Henry + Associates Project No. 21-32-052

DSA File No. 39-50

DSA Application No. 02-120455

ADDENDUM NO. 02
Modernization Lakewood Elementary School (Summer 2025)
Lodi Unified School District
Lodi, California

ENLARGED PARTIAL SITE PLAN

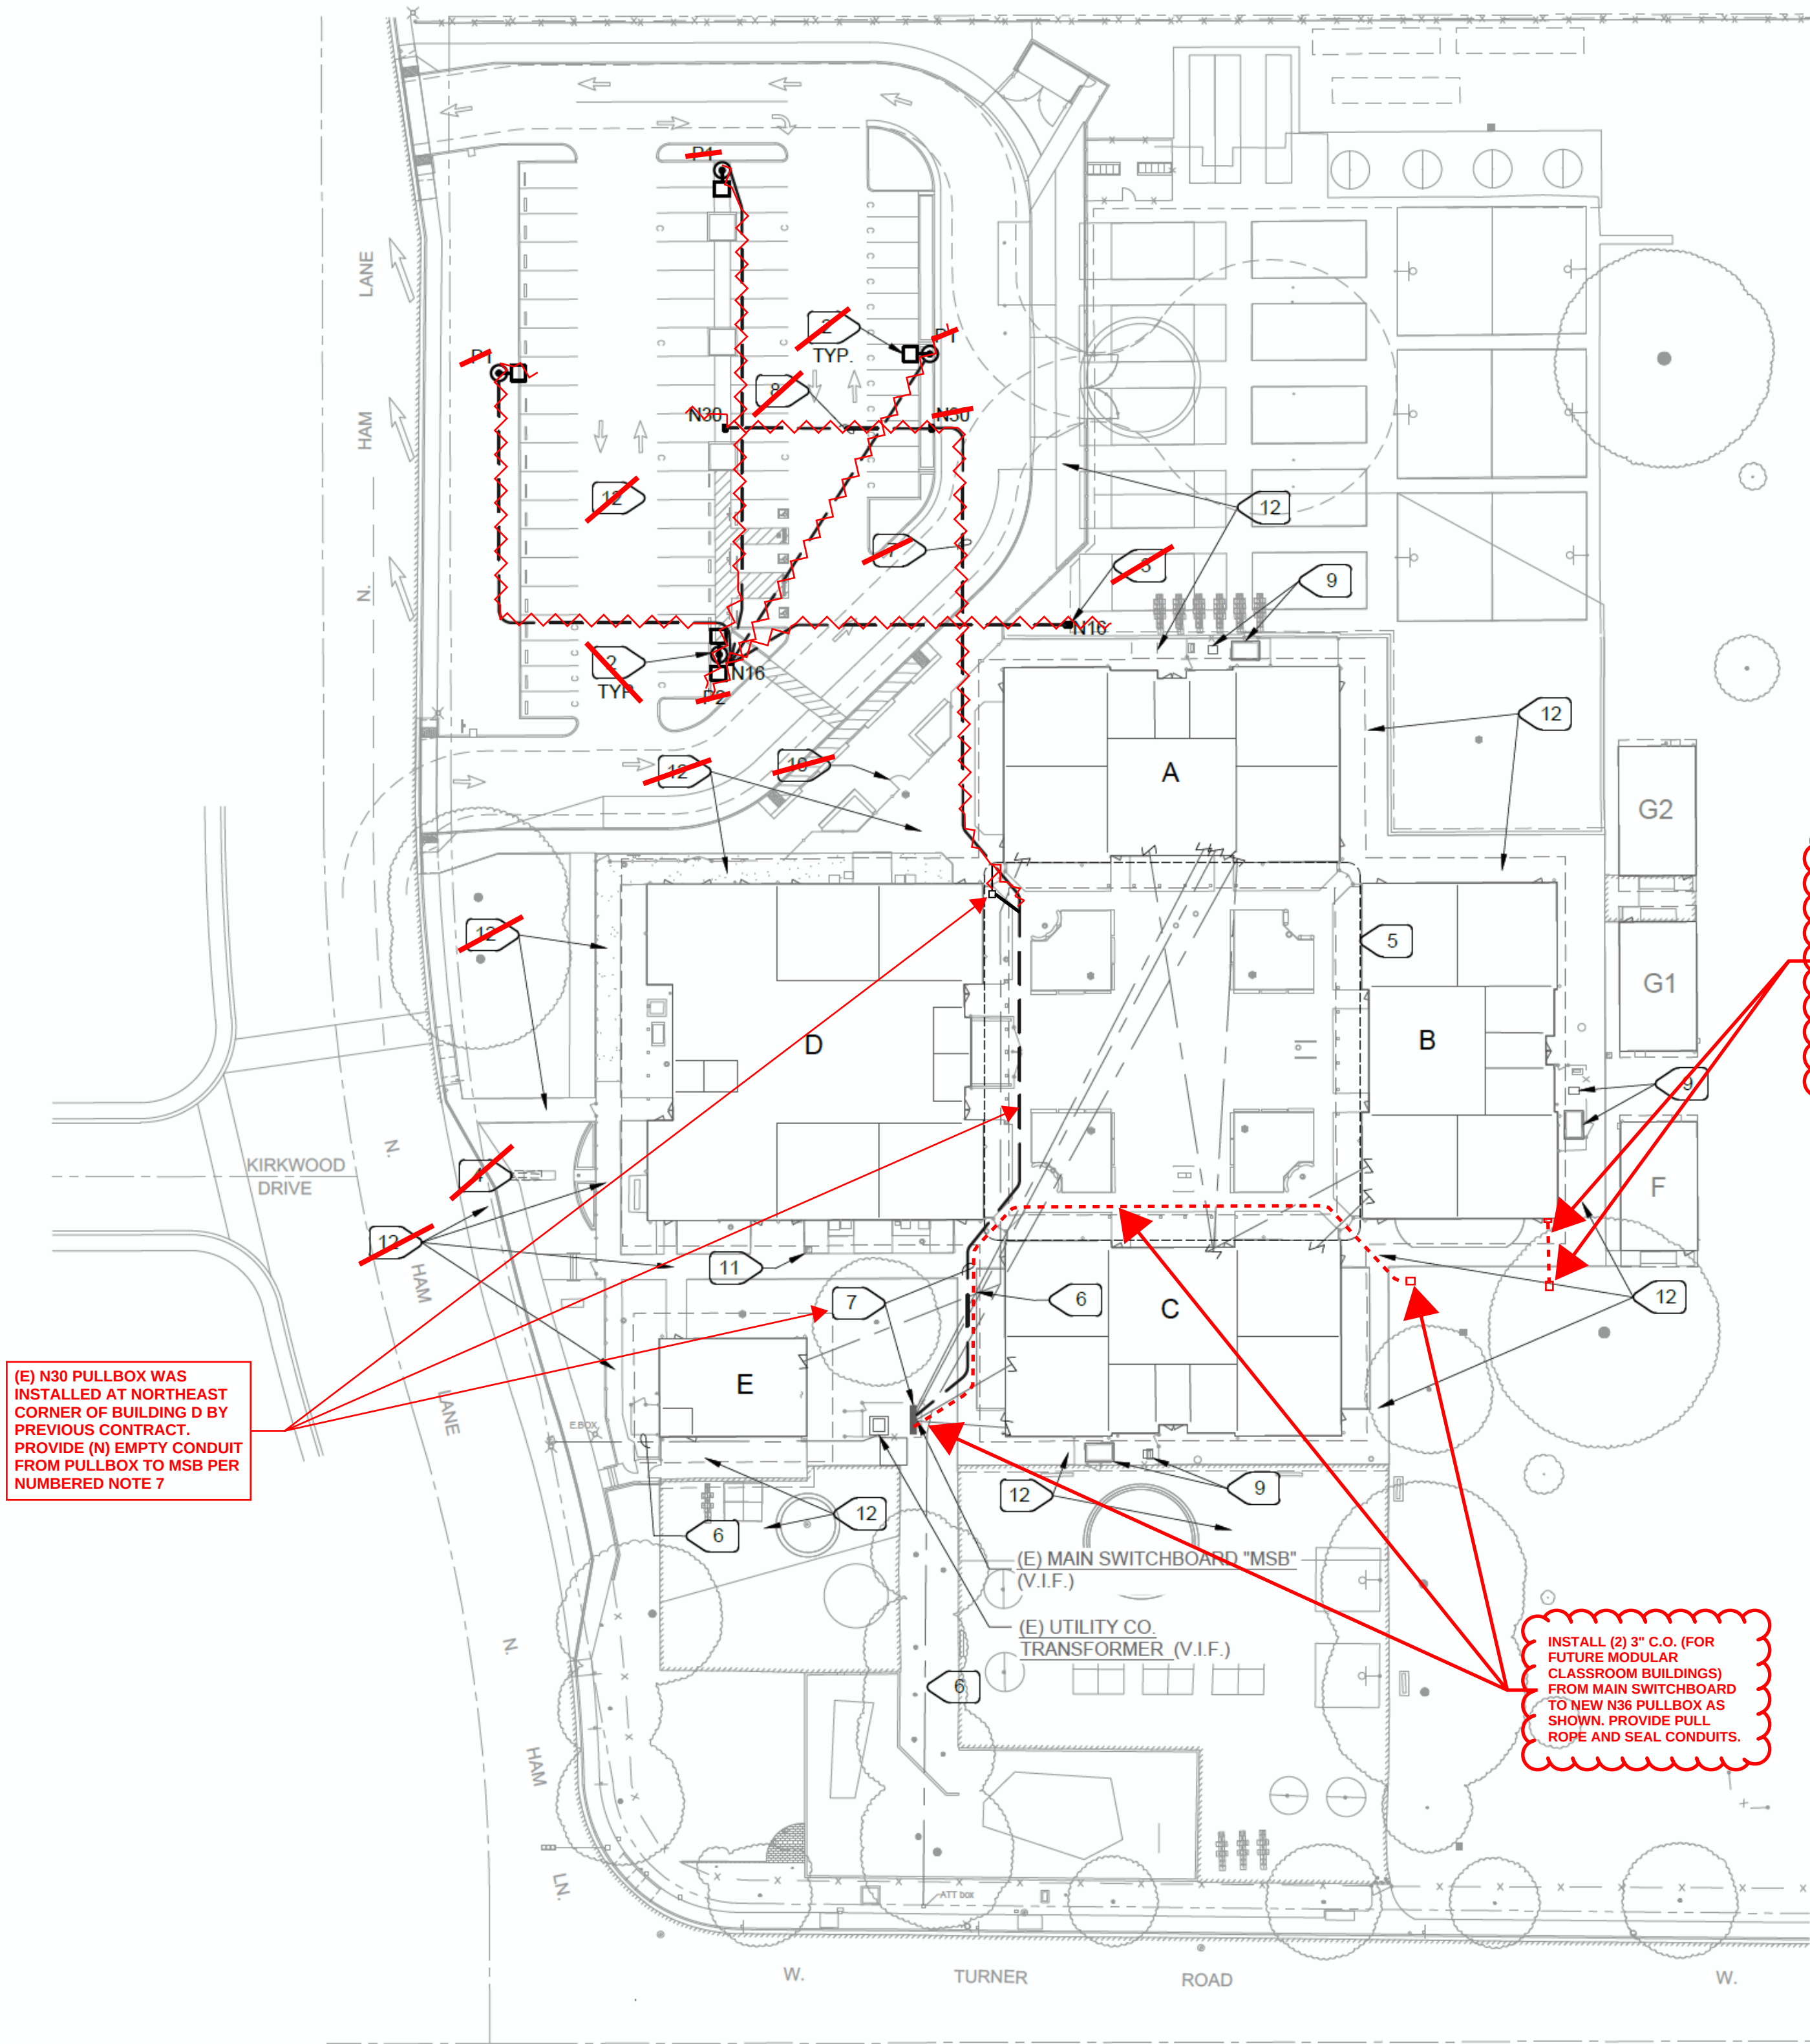
REMOVE (E) CLF GATES AND FABRIC AND
DISCARD.
PROVIDE **ALL NEW** CLF COMPONENTS AT HVAC
YARDS PER THE FOLLOWING:
1. ALL GATES, GATE HARDWARE & GATE FABRIC
2. ALL TOP RAILS
3. ALL CLF FABRIC WITH NEW PRE-SLATTED CLF
FABRIC PER BELOW SPECIFICATION
4. ALL NECESSARY CLF FABRIC MOUNTING AND
TENSIONING HARDWARE FOR A COMPLETE
INSTALLATION

NOTE:
REMOVE UNISTRUT SUPPORTS BELOW
ALL PIPING AND TEMPORARILY
SUPPORT DURING DEMOLITION & (N)
CONSTRUCTION. REPLACE AND
RECONNECT AFTER (N) WALKWAY IS
POURED.

REMOVE (E) DUCT SUPPORTS AND
TEMPORARILY SUPPORT DUCTS DURING
DEMOLITION AND (N) CONSTRUCTION
OPERATIONS. REINSTALL @ COMPLETION

"VIEWGUARD PLUS", COMMERCIAL SLATTED FENCING AS MANUFACTURED/DISTRIBUTED BY SECURITY
CONTRACTOR SERVICES, INC. OR APPROVED EQUAL. CONTRACTOR MAY ALSO USE PRE-SLATTED CLF FABRIC
AS SPECIFIED IN PROJECT MANUAL SECTION 32 33 00. SLAT COLOR TO BE SELECTED BY OWNER.

SITE PLAN - ELECTRICAL

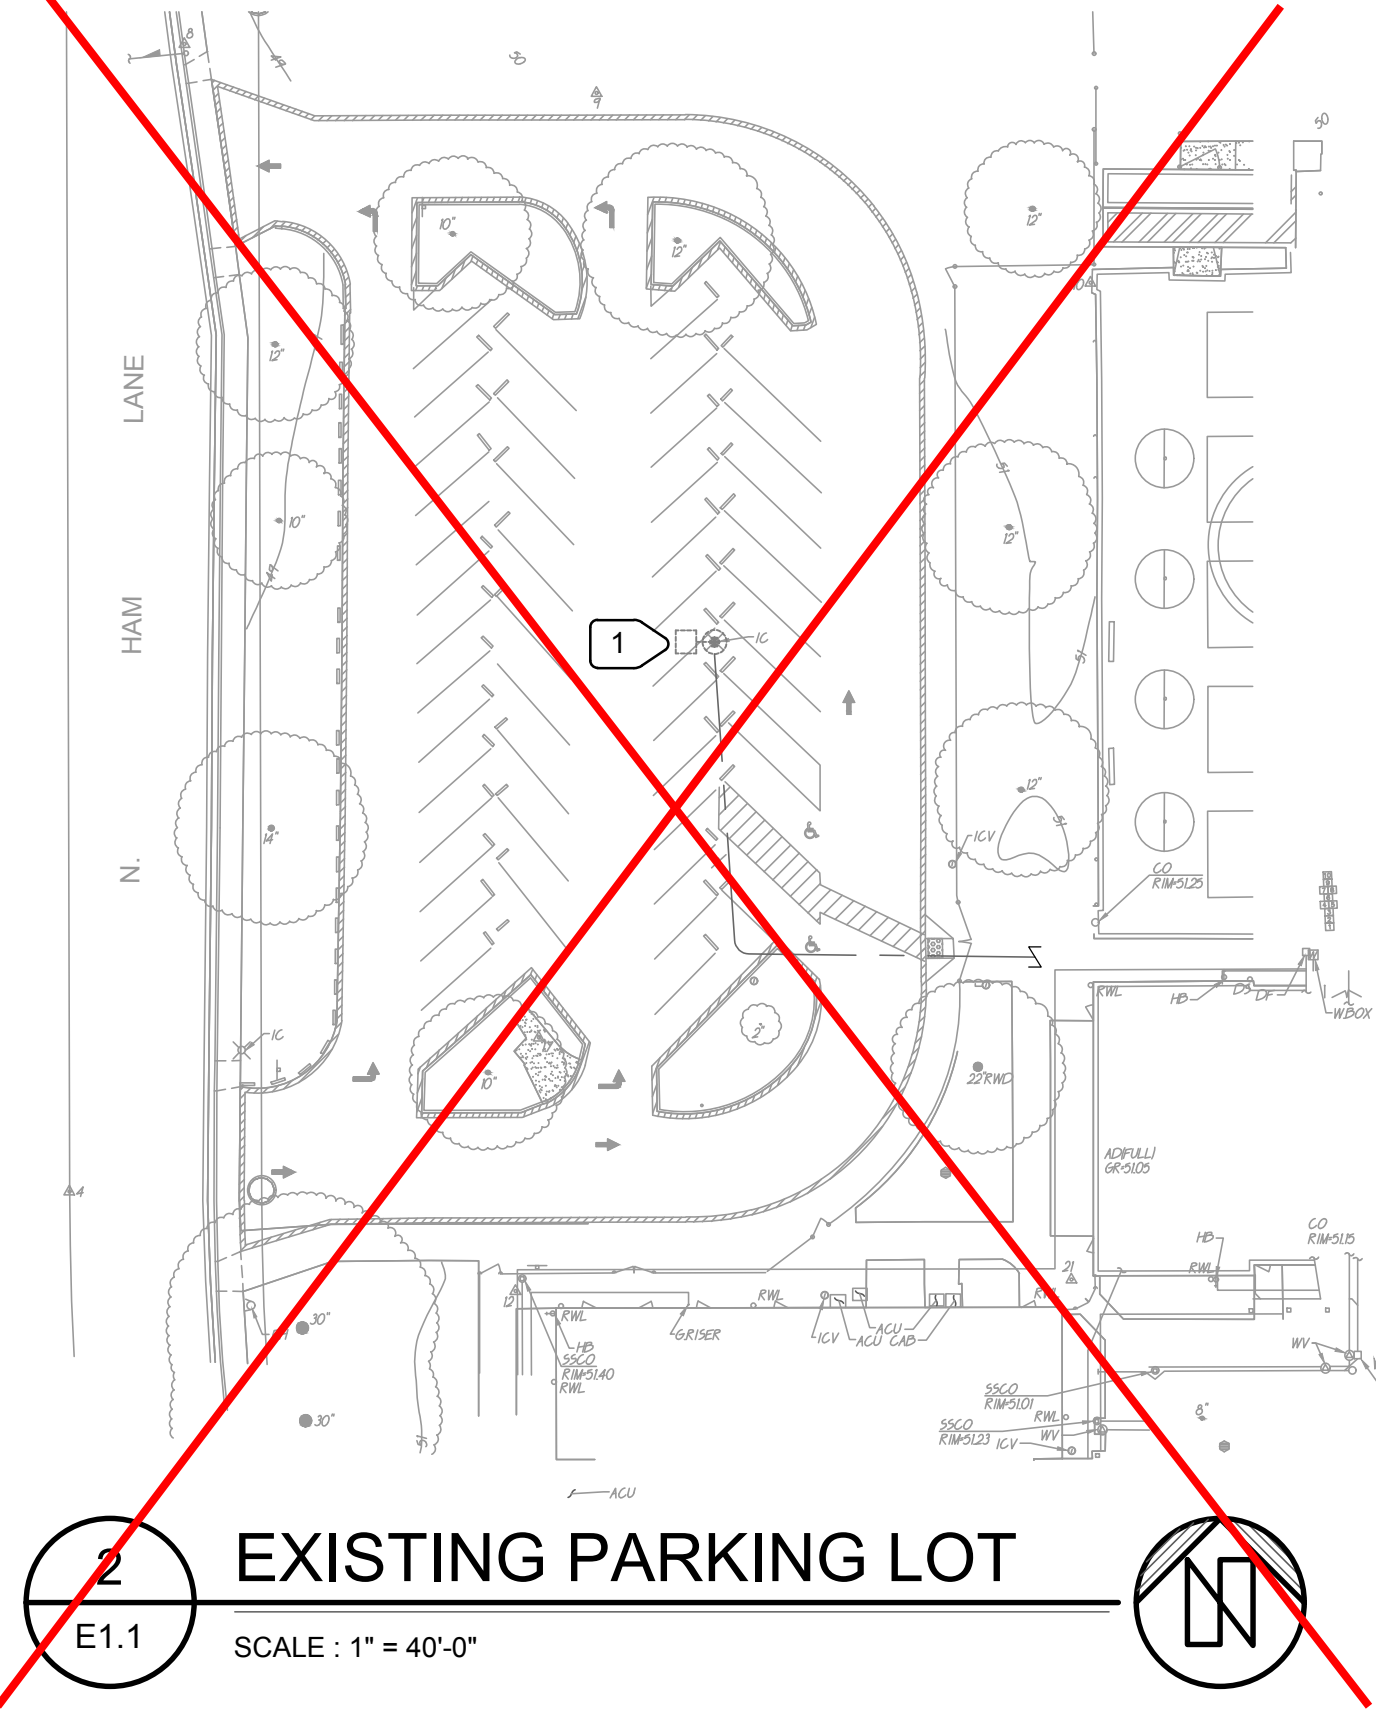
- A. SHEET A1.1.2, SITE PLAN:
 - 1. REVISE the "PHASE 2" note under the "PHASING NOTE" to read:
"PHASE 2 – COMPLETE A.C. GRINDING, OVERLAY, SEALING AND STRIPING AT HARD COURTS FOLLOWING COMPLETION OF THE PHASE 1 SCOPE. IF NECESSARY, THE OWNER WILL ALLOW THE PHASE 2 WORK TO BE COMPLETED DURING THE SCHOOL DISTRICT'S 2-WEEK FALL BREAK FROM 9/29/25 TO 10/10/25."
- B. SHEET A1.2.1, ENLARGED SITE PLANS:
 - 1. REPLACE detail 4/A1.2.1, ENLARGED PARTIAL SITE PLAN with the attached, revised detail AD2.01. The scope has been revised.
- C. SHEET E1.1, SITE PLAN - ELECTRICAL:
 - 1. REPLACE SHEET E1.1-SITE PLAN – ELECTRICAL with revised sheet E1.1, SITE PLAN – ELECTRICAL. Installation of empty conduit, pullboxes and electrical enclosures has been added for future power, fire alarm and data to serve future modular classroom buildings.

- 6 (E) CONDUIT - PROTECT DURING DEMOLITION AND CONSTRUCTION. CONTRACTOR SHALL USA AREA BEFORE START OF DEMOLITION.
 - 7 (2) 3" C.O. FOR FUTURE E.V. CHARGERS, FROM MAIN SWITCHBOARD TO PULLBOXES AS SHOWN. PROVIDE PULL ROPE AND SEAL CONDUITS.

- ~~8 3" C.O. FOR FUTURE E.V. CHARGERS. PROVIDE PULL ROPE AND SEAL CONDUIT.~~
 - 9 (E) HVAC UNIT. ELECTRICAL CONTRACTOR SHALL TEMPORARY SUPPORT (E) EXPOSED CONDUITS/CONDUCTORS TO UNITS TO ALLOW NEW CONCRETE WALKWAY TO BE INSTALLED. AFTER (N) CONCRETE IS IN PLACE REINSTALL (E) CONDUIT/CONDUCTORS TO NEW WALKWAY/CONCRETE.
